## MEMORANDUM

**Subject:** Review Response for Geotechnical Review – 6472 and 6498 South Bybee Drive, Weber County Parcel Numbers: 07-753-0001 and 07-753-0002 Uintah, Utah

GeoStrata has received review questions of our report titled **Geotechnical Investigation for Dauphine-Savory Piedmont Subdivision Lots 1R and 2R and adjacent 2-acre property, Weber County, Utah**, GeoStrata Job Number 910-001 and dated December 10, 2013. We understand that a second memorandum prepared by GeoStrata titled **“Review of Proposed Residential Development – Dauphine-Savory Piedmont Subdivision, GeoStrata Project #910-001**, dated May 8, 2014 was also reviewed. The reviews were completed by Mr. Alan Taylor, P.E. of Taylor Geotechnical. This memorandum was prepared in response to the review questions presented in a letter dated December 2, 2014.

**Plate  
 A-1**

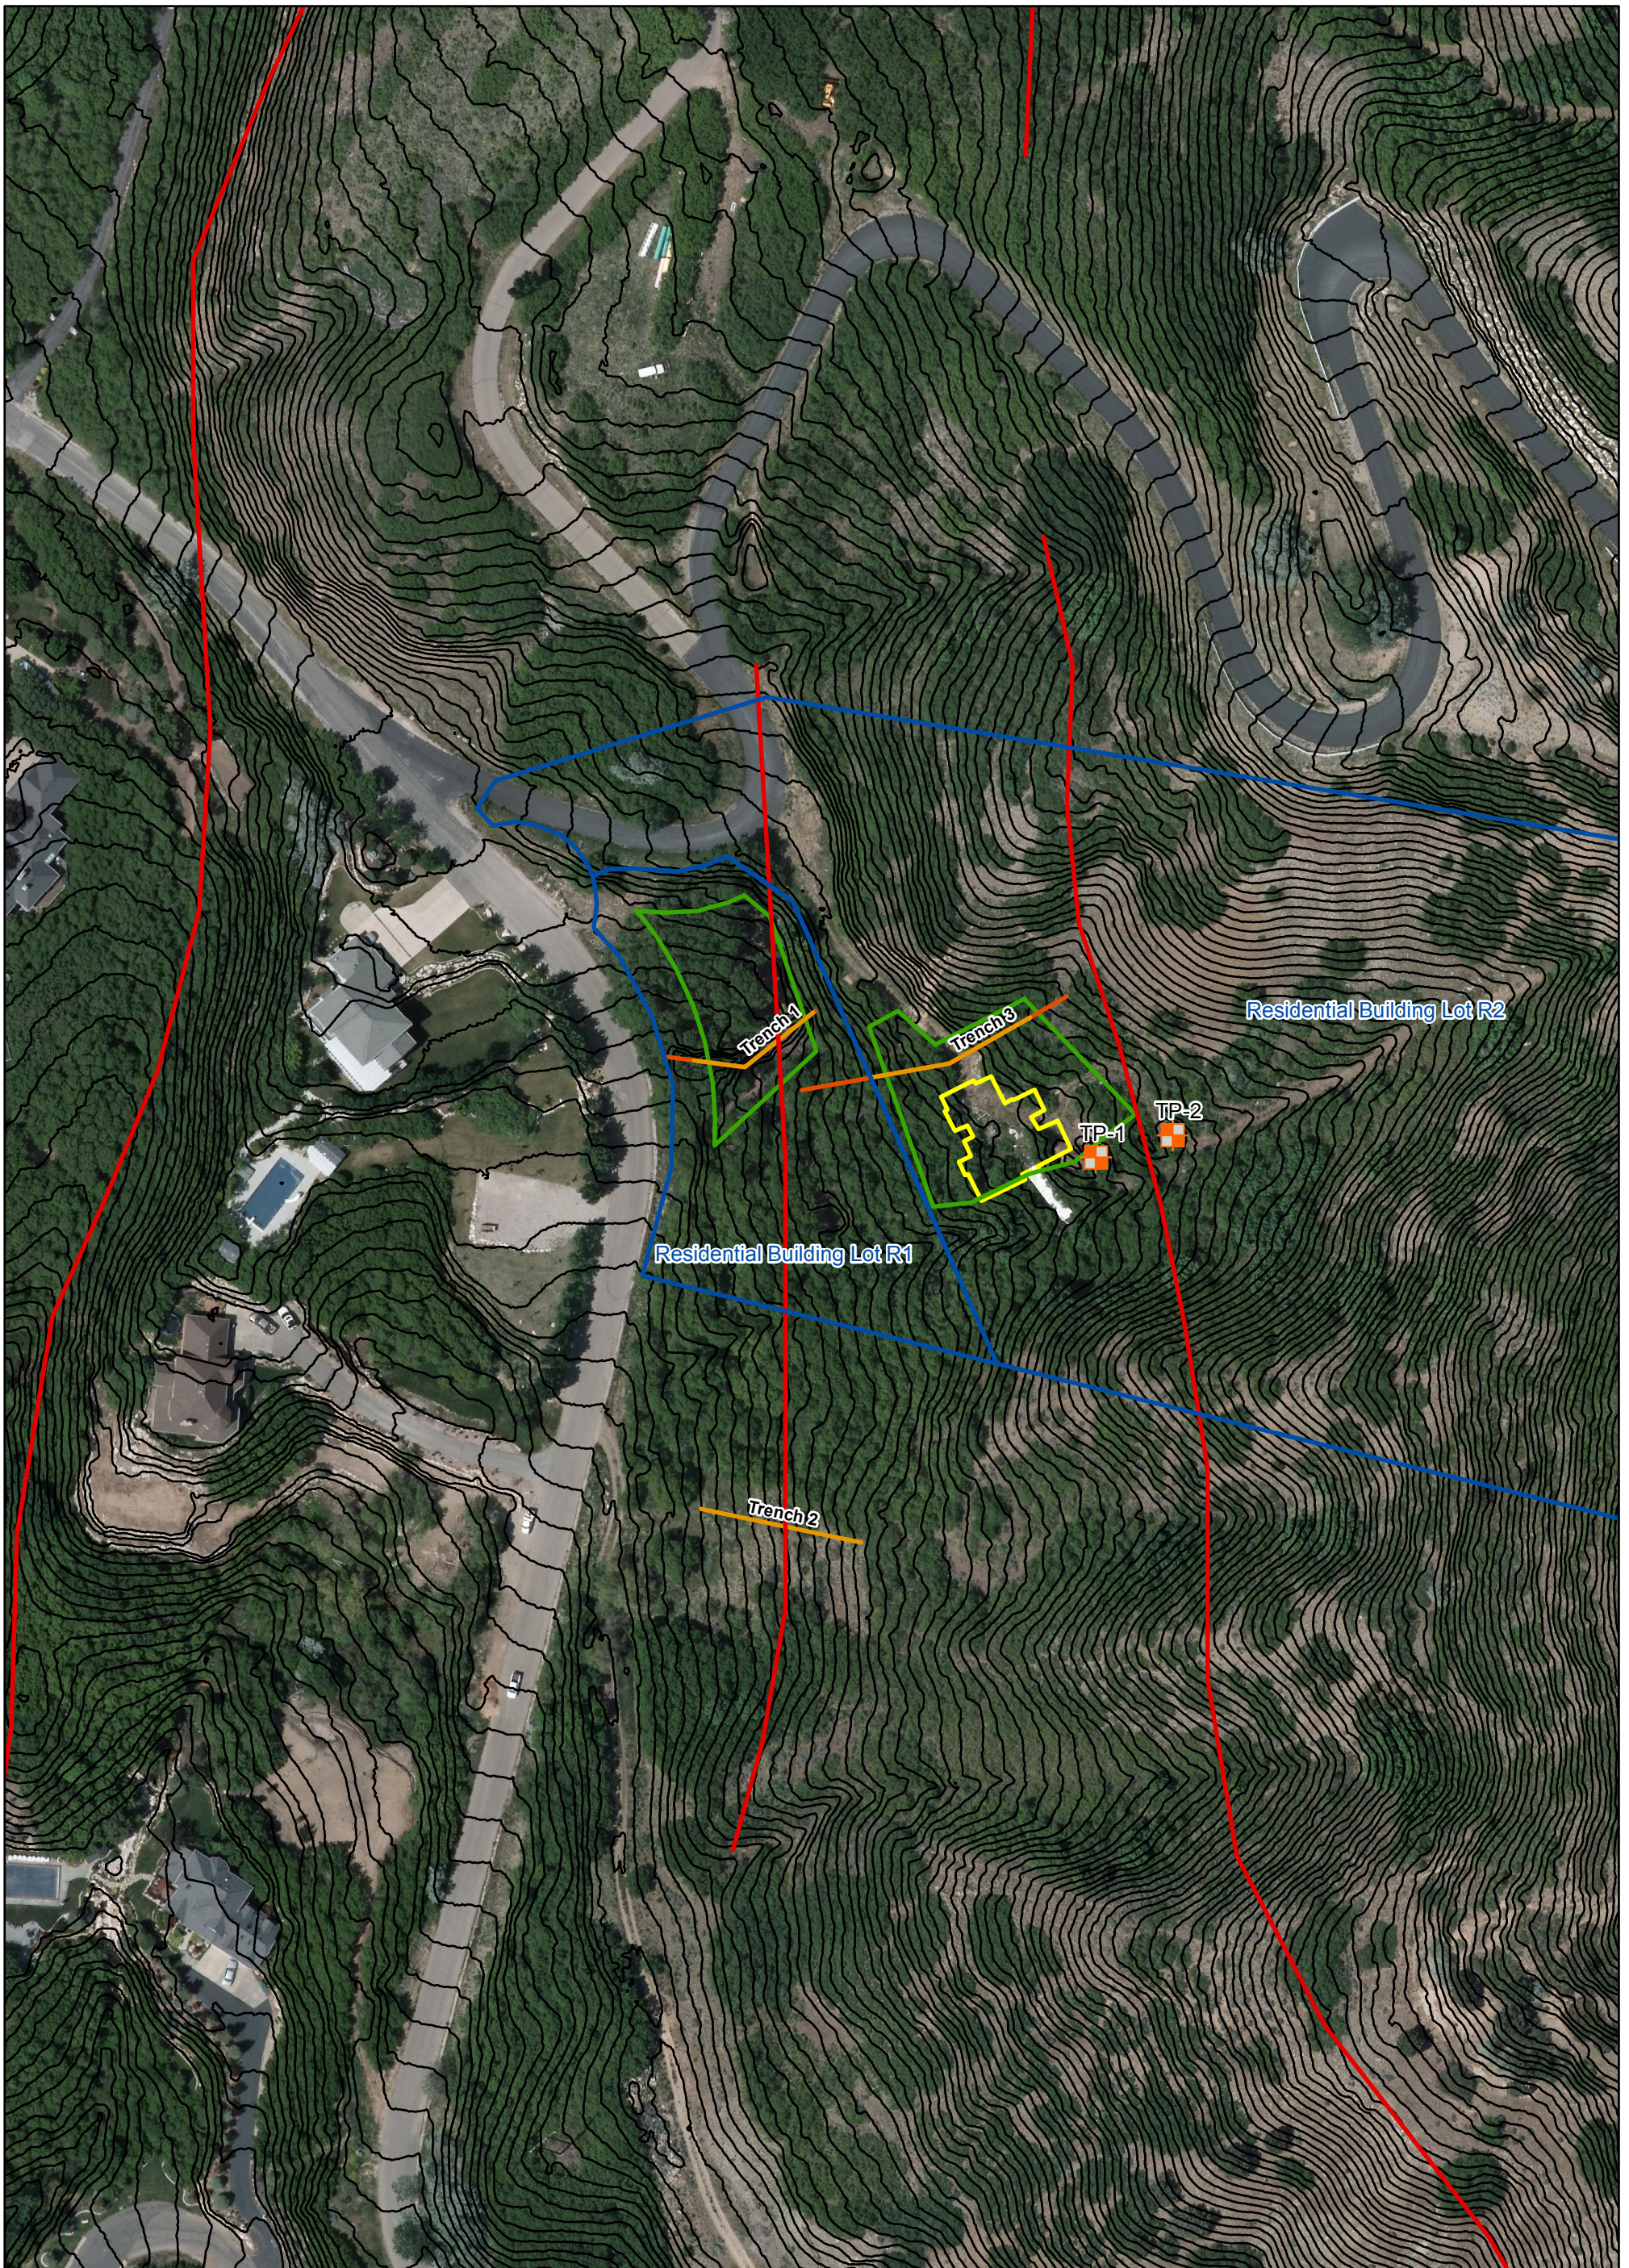
1. TGE requests that “The location of the test pits be shown on the site plan for the proposed home.”

**GeoStrata Response:** GeoStrata has completed an updated site plan containing the requested information. A site vicinity map and site exploration map may be found attached to the end of this letter as Plates A-1 and A-2, respectively. It should be noted that GeoStrata has completed additional field work in order to further assess the geologic nature of the site. This additional work included the excavation of an additional trench (Trench 3) as well as deepening the previously completed trenches (Trench 1 and 2). While no additional geotechnical testing was completed as part of that investigation, the subsurface soils were observed and our geotechnical recommendations were re-evaluated. Updated hand logs of Trenches 1 and 3 have been attached to the end of this letter as Plates B-1 to B-4. Trench 2 was omitted as the Client wishes to focus on residential building lots 1R and 2R. The neighboring 2-acre parcel will be covered in a future report.

Plate A-3

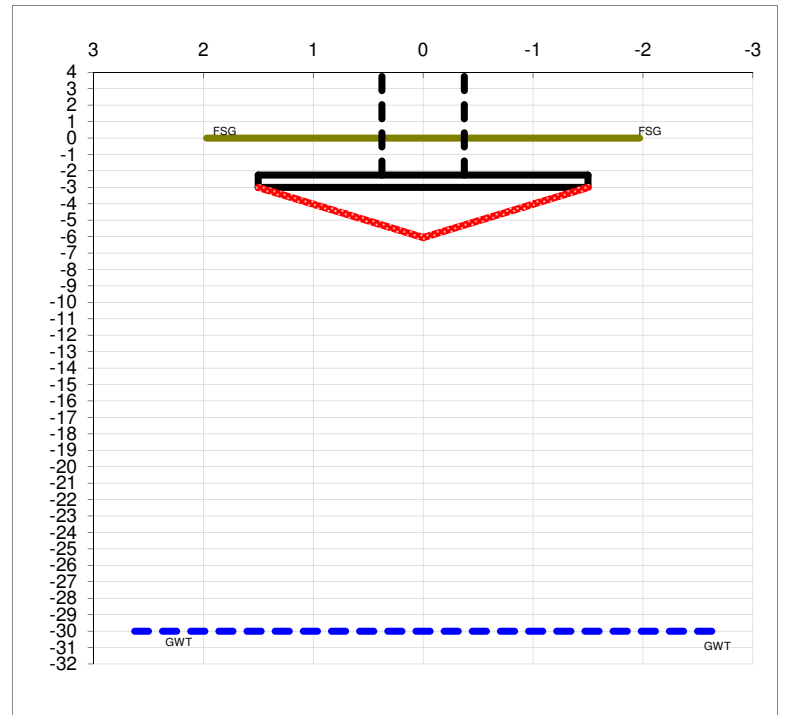
2. TGE requests that GeoStrata submit “Engineering calculations that substantiate the recommended allowable bearing capacity and settlement analysis.”

**GeoStrata Response:** GeoStrata has attached our calculations for our bearing capacity recommendations to the end of this letter as Plate A-3. In our previous geotechnical report, a

soil friction angle ( $\phi$ ) of 28° and a cohesion value of 200 psf were assumed. GeoStrata has completed a direct shear test on a sample of the near-surface soils in order to complete a rockery design for the project, and in doing so has obtained a friction angle of 31° and a cohesion of 445 psf. Results of our laboratory testing have been attached to the end of this letter as Plate A-5. Due to the granular nature of the native, near-surface soils, GeoStrata was unable to obtain a suitable undisturbed sample for consolidation testing. As such, a Cc and Cr value could not be obtained. Due to the sandy nature of the soils observed, it is likely that the settlement involved with this project will be immediate settlement and is anticipated to be less than one inch as long as the foundations are constructed as described in our 2013 geotechnical report.

# DIRECT SHEAR TEST

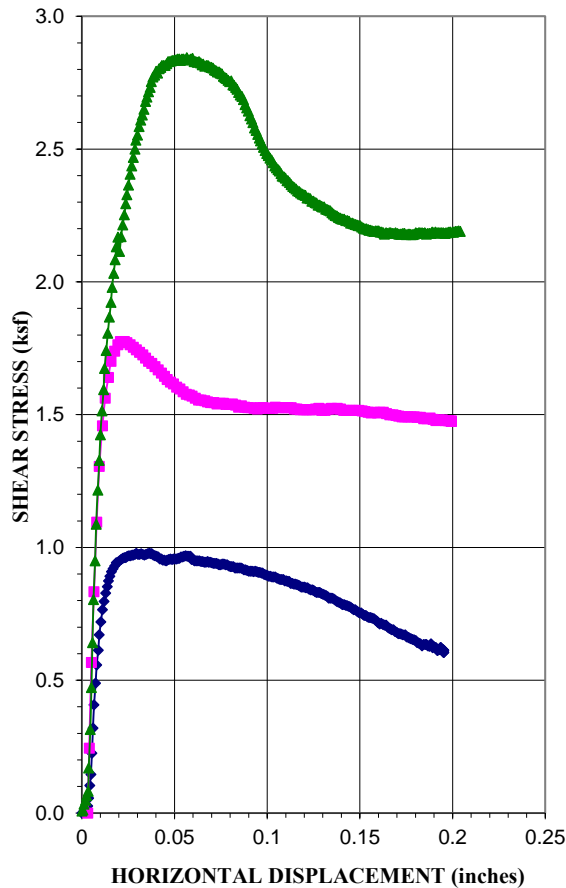
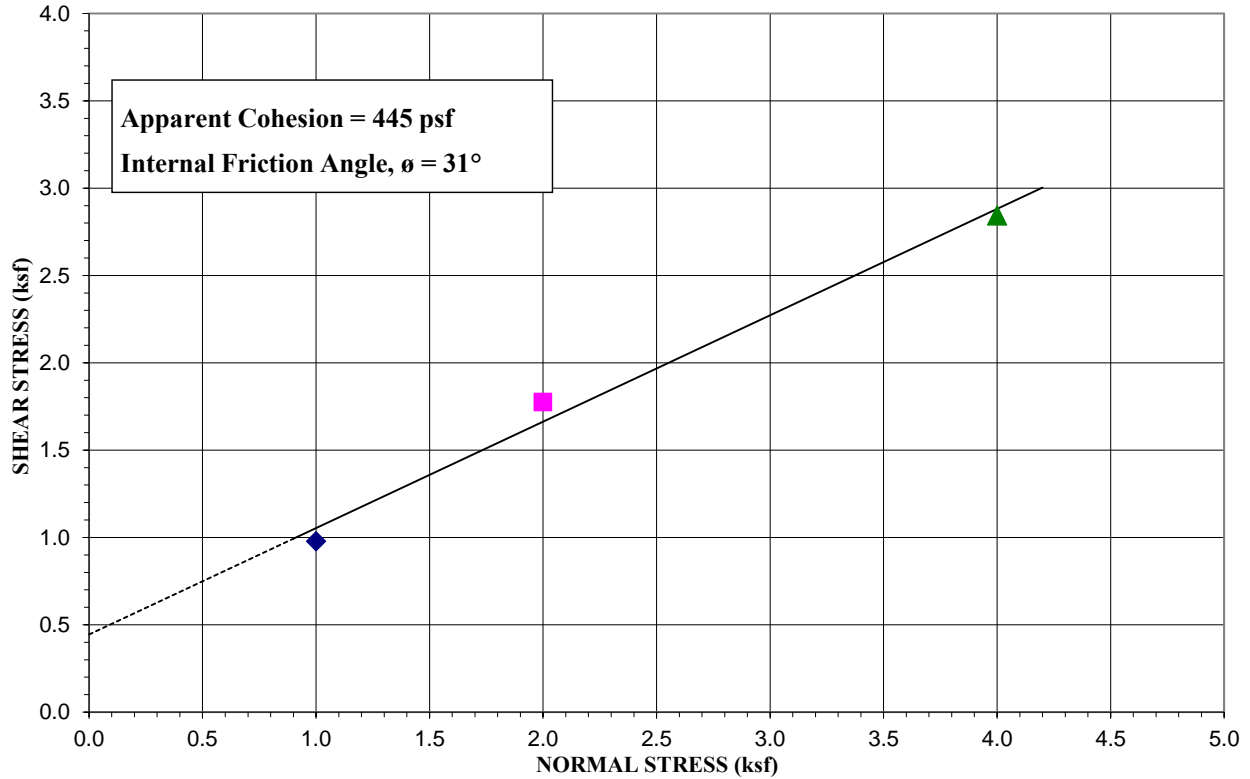
3. TGE requests that GeoStrata submit “Engineering calculations that substantiate the recommended lateral earth pressure coefficients and equivalent fluid densities for active, at-rest and passive conditions.”

**GeoStrata Response:** GeoStrata has attached the requested information to the end of this letter as Plate A-4. As discussed above, our previously assumed soil strengths have been updated using laboratory-obtained soil strengths, and as a result these values will differ from the values originally stated in our 2013 geotechnical report.

**Plate  
 A-6**

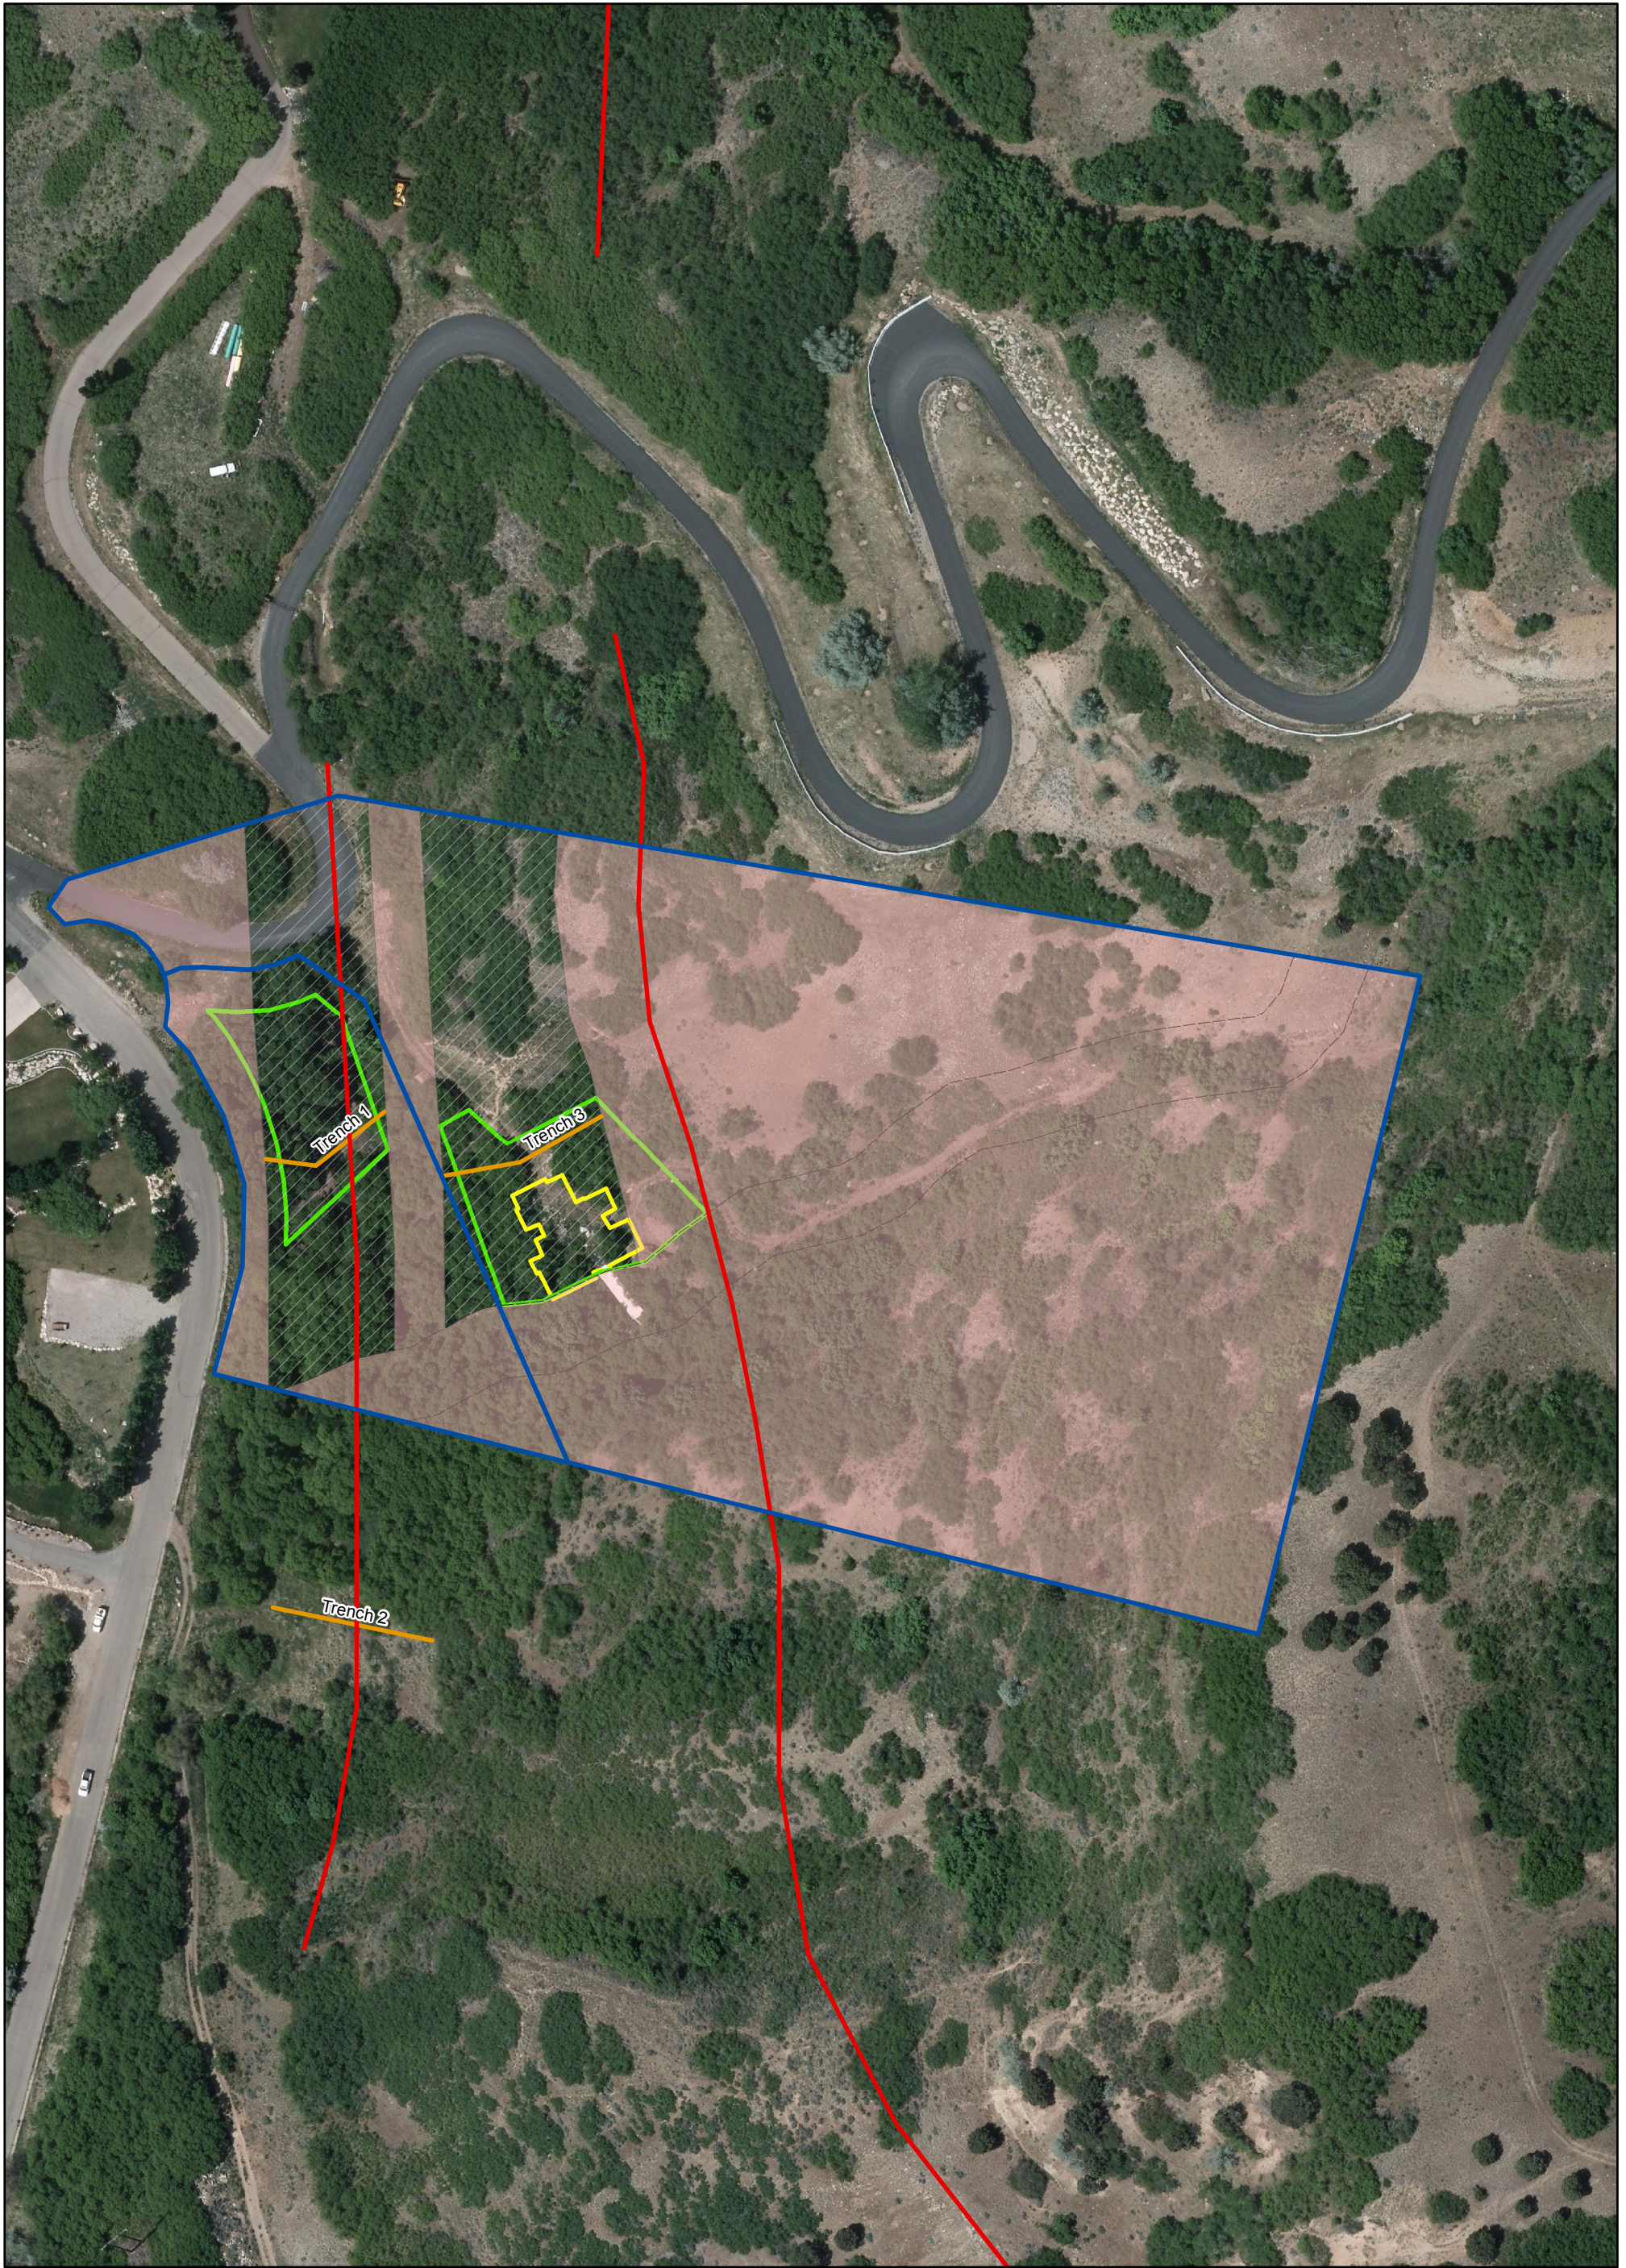
5. “Based on Plate A-2 of the subject report, it is not clear if the trenches excavated for the fault study confirm if the proposed building lot is free from active faults. Therefore, a site plan should be submitted that contains the location of the home and locations of the trenches used for the geologic study.”

**GeoStrata Response:** GeoStrata has prepared a plate showing the location of the proposed residences as well as the area cleared by the trenches. This plate has been attached to the end of this letter as Plate A-6.
